ADDENDUM NO.: 4

PROJECT NAME: **POLICE TRAINING ACADEMY HVAC COMPONENT REPLACEMENT**

DATE: 7/15/2013

CIMS PROJECT NO.: **35-06010**

SHEET
M5.2
OF:

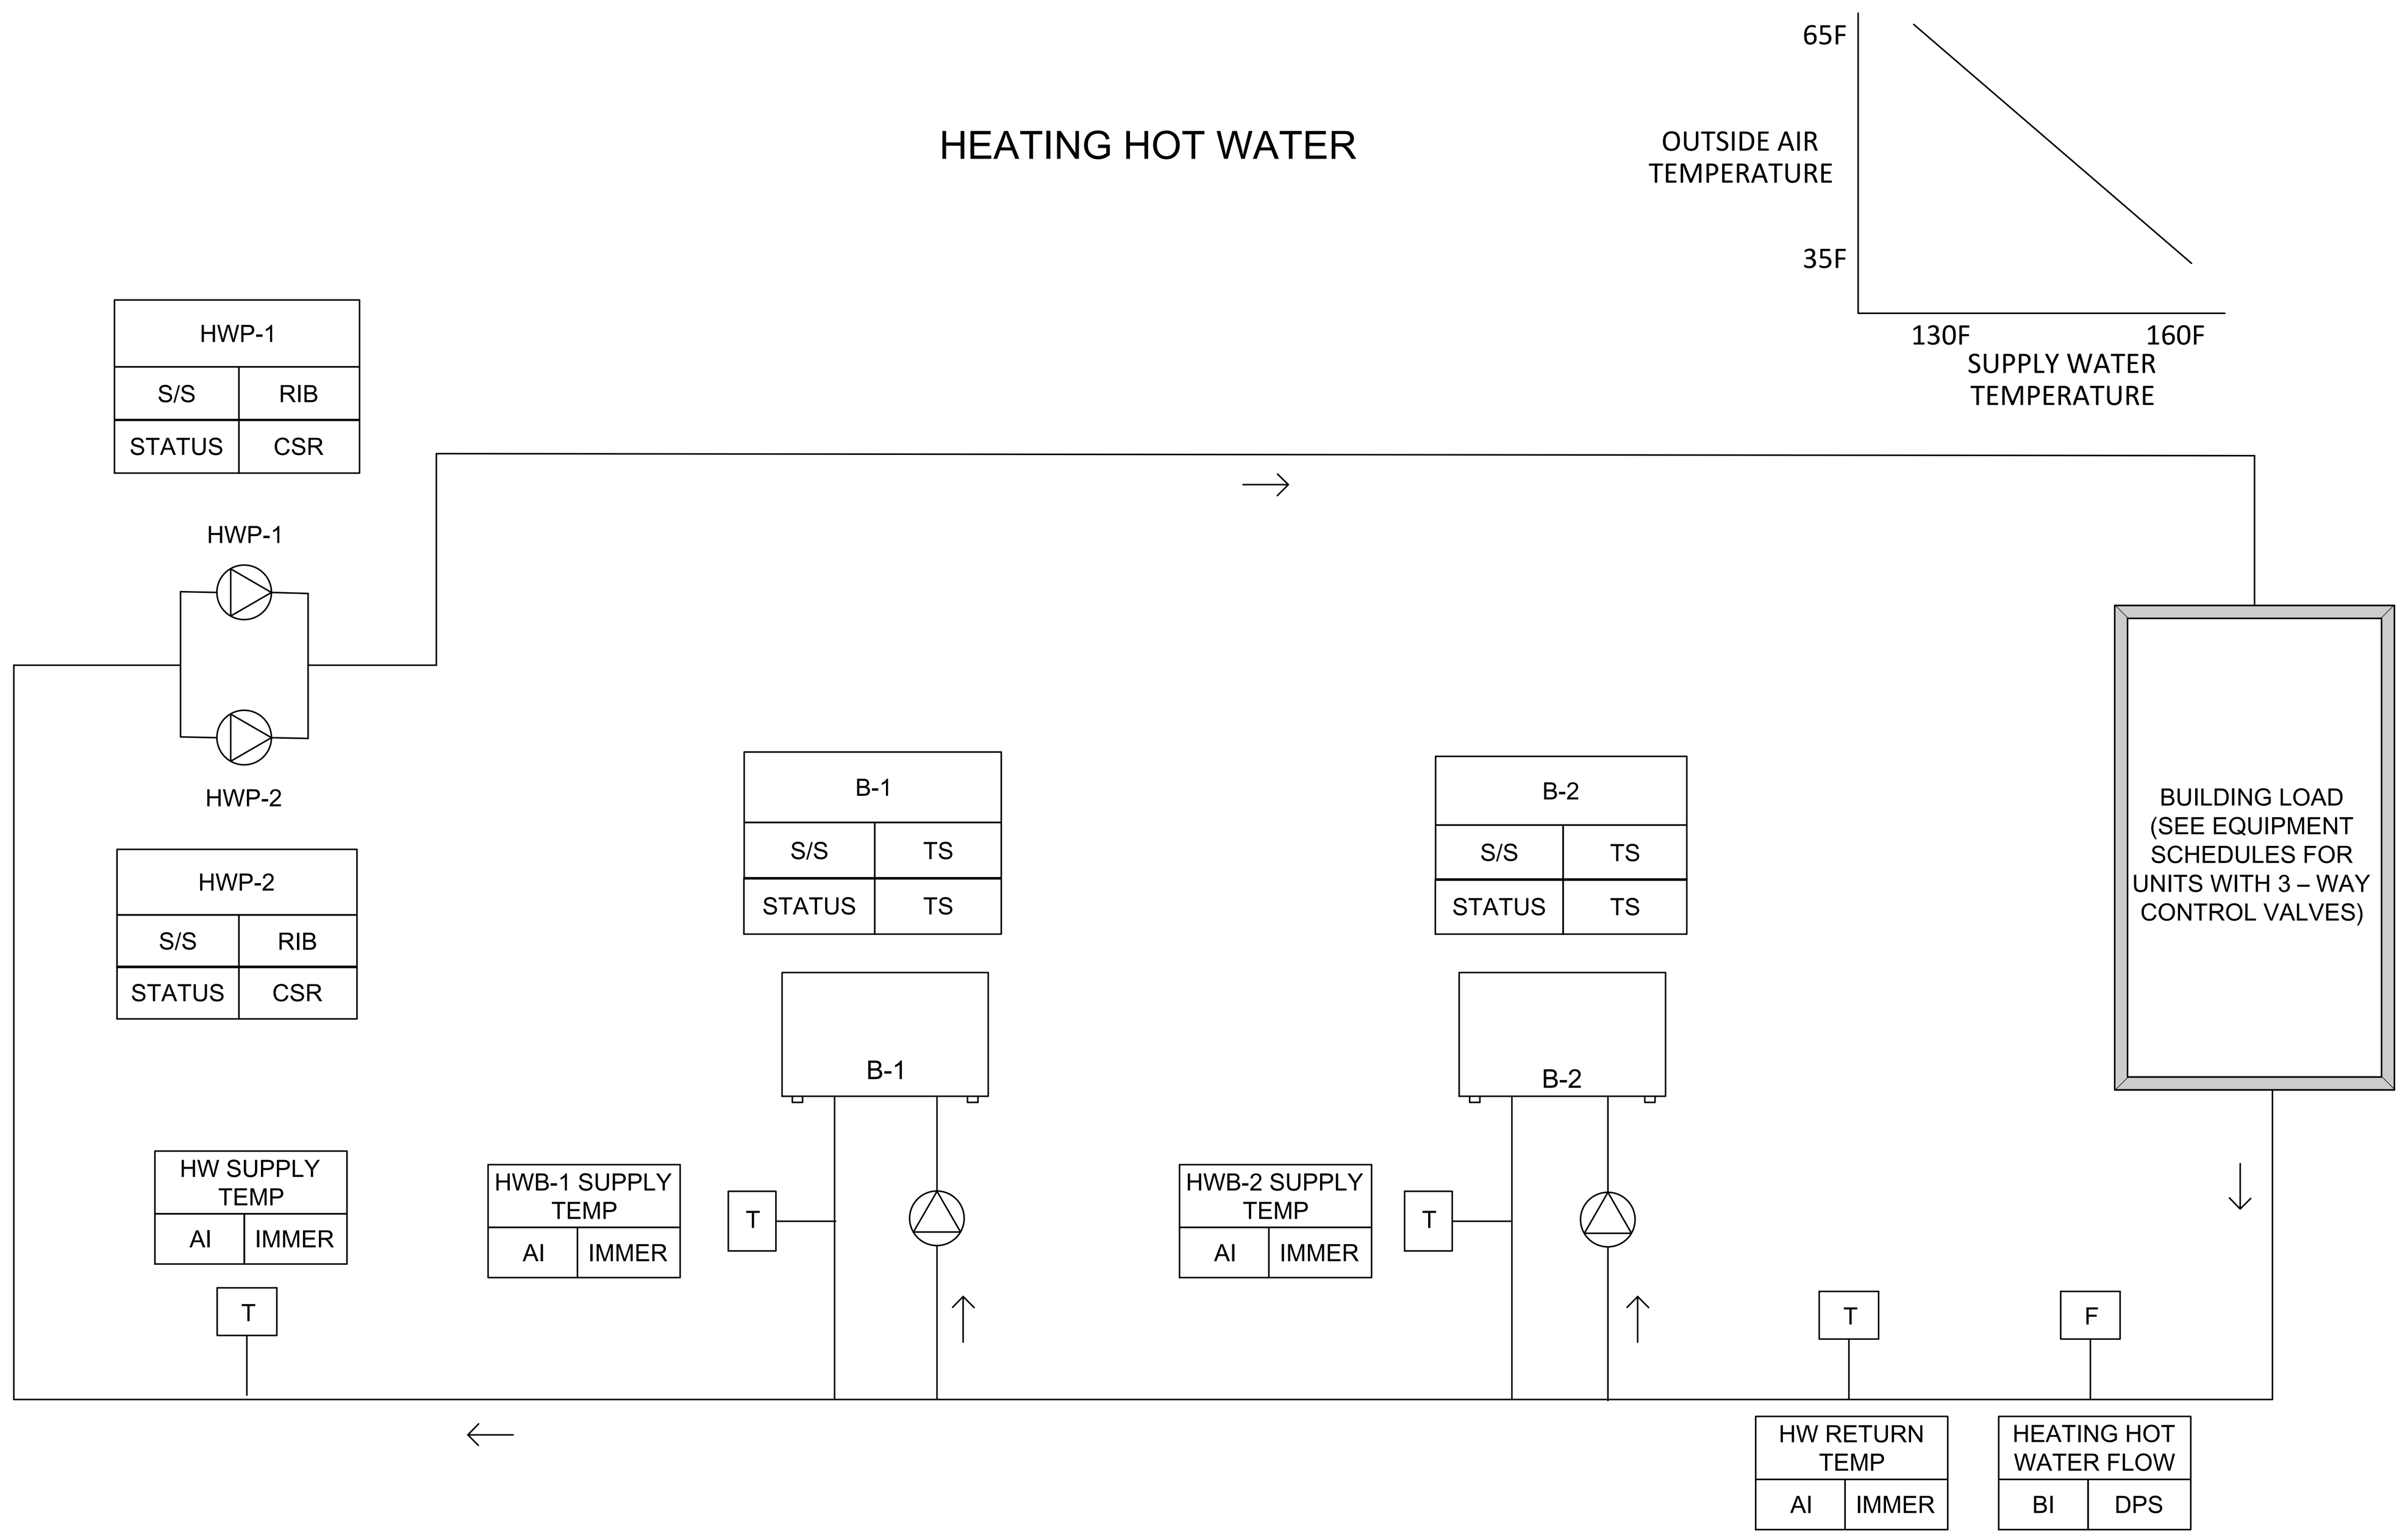
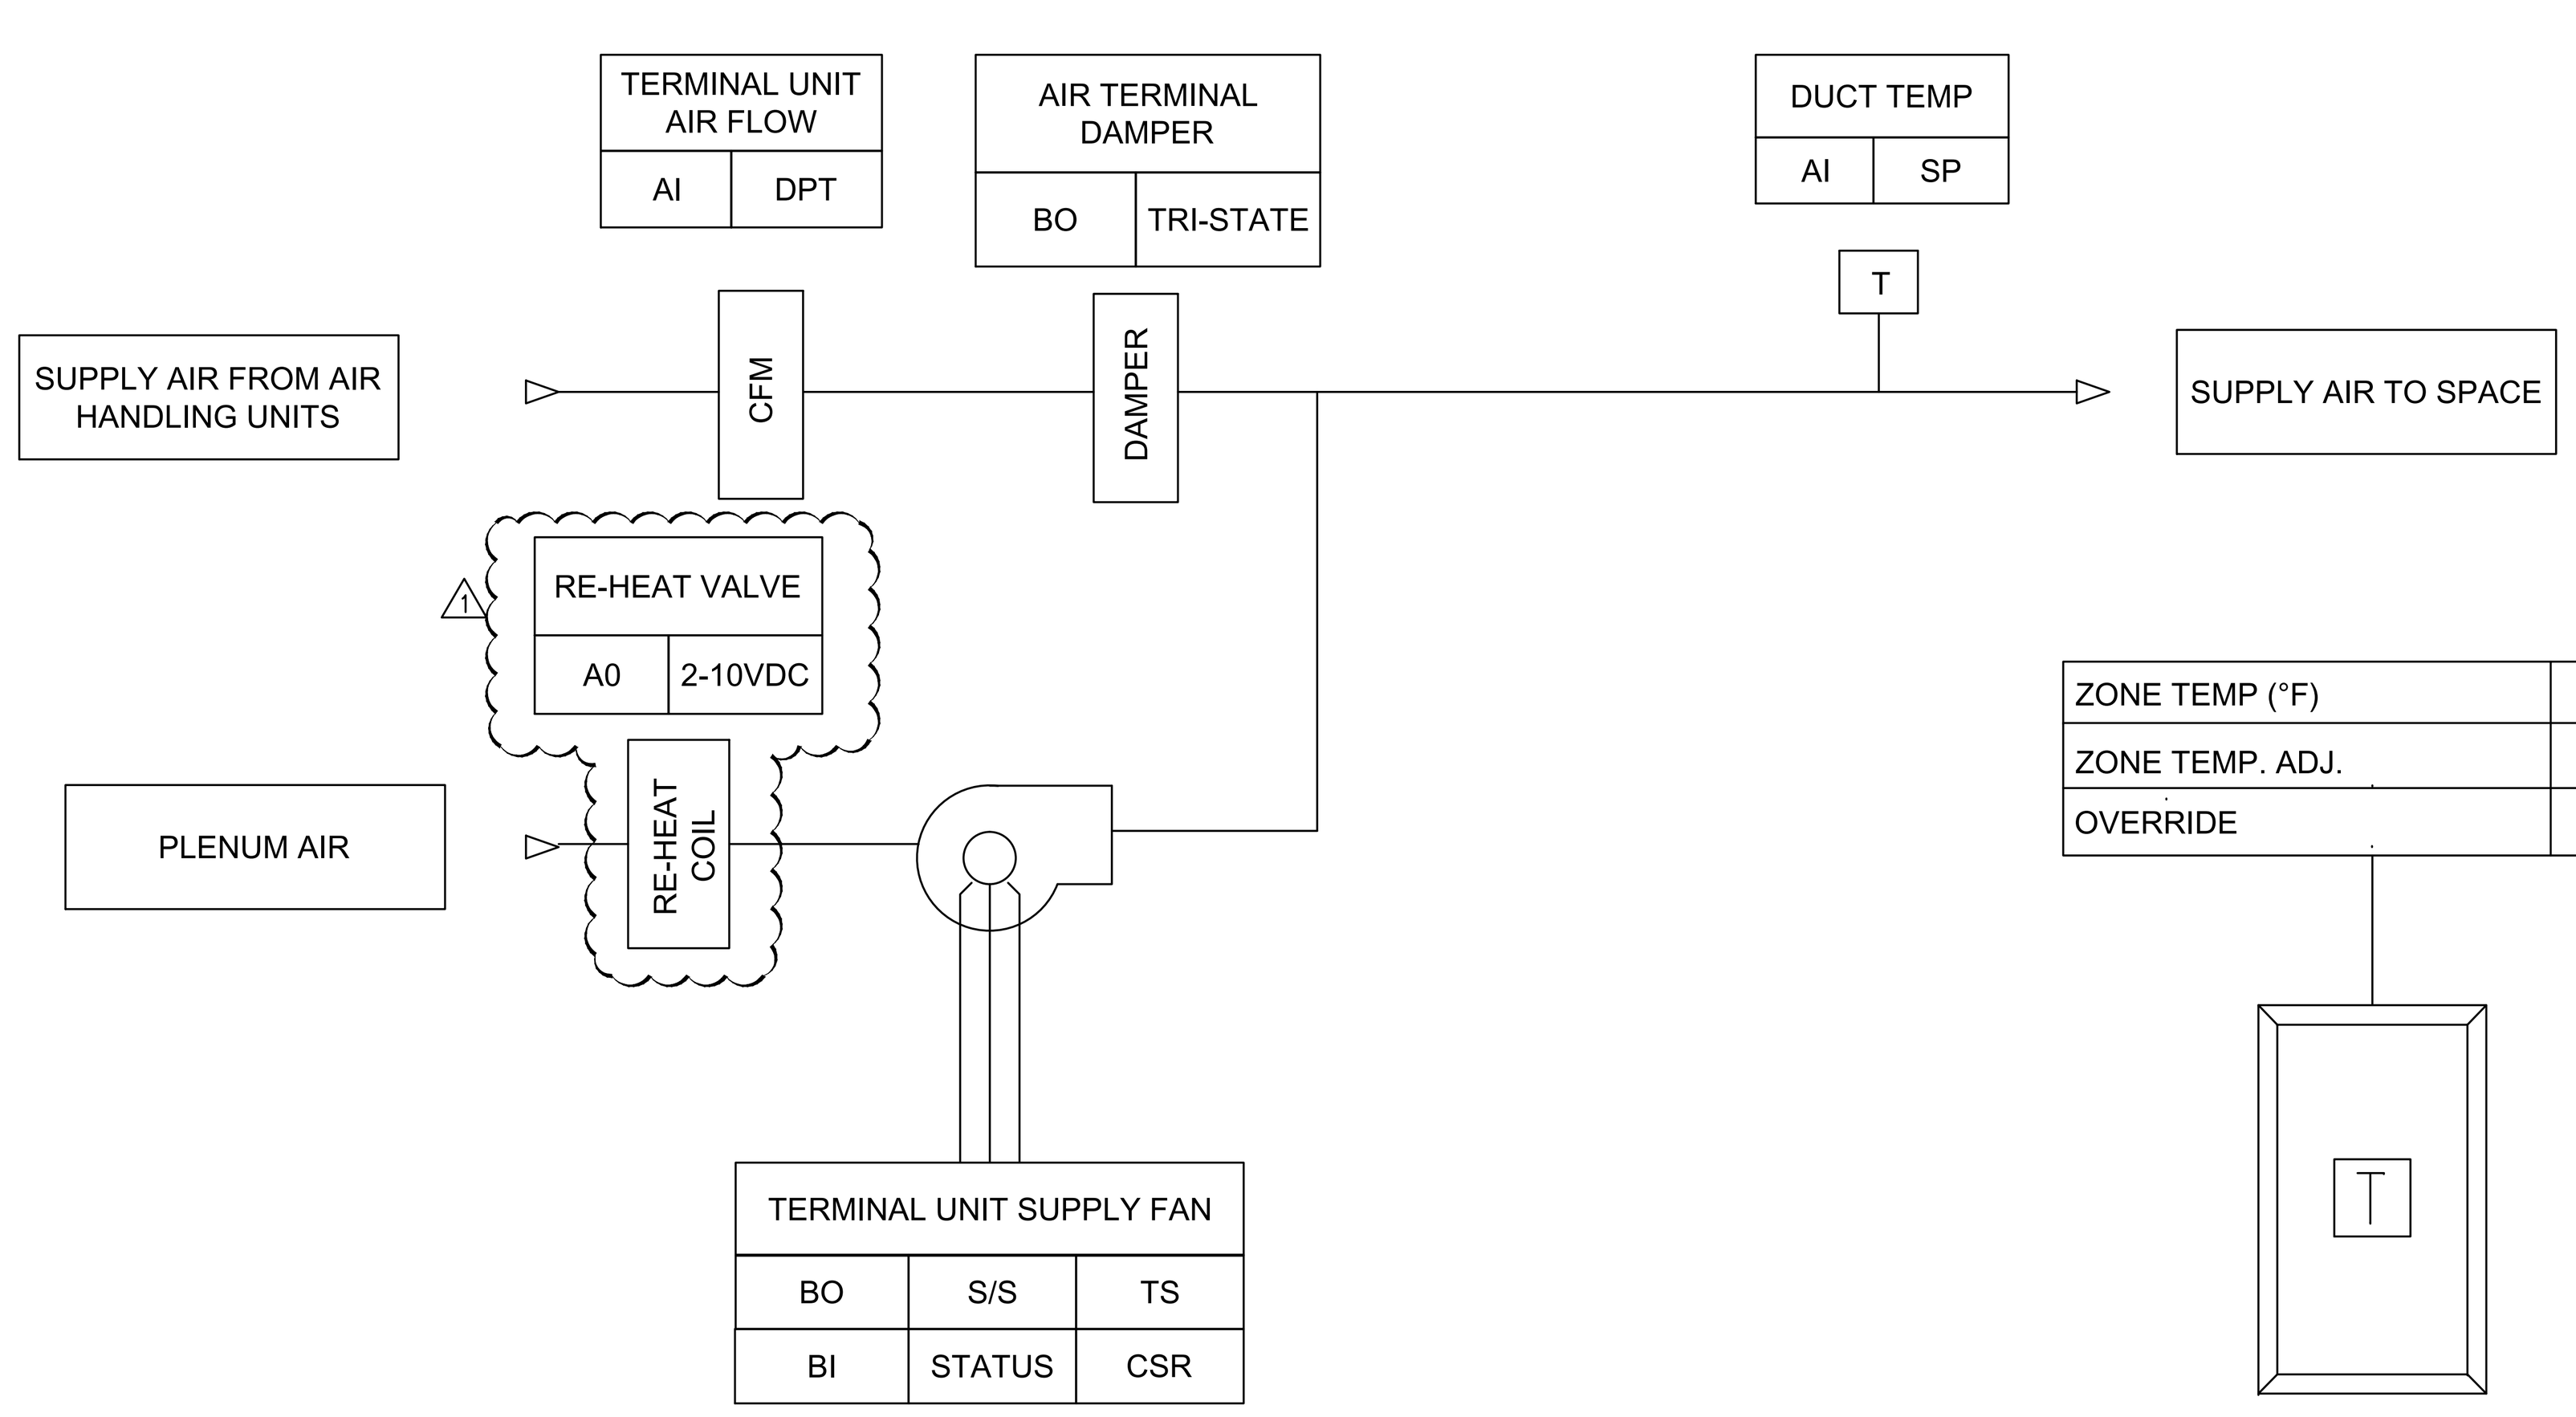
PLAN SHEET M5.2

- Revise Detail No.'s 1, 2 and 3.
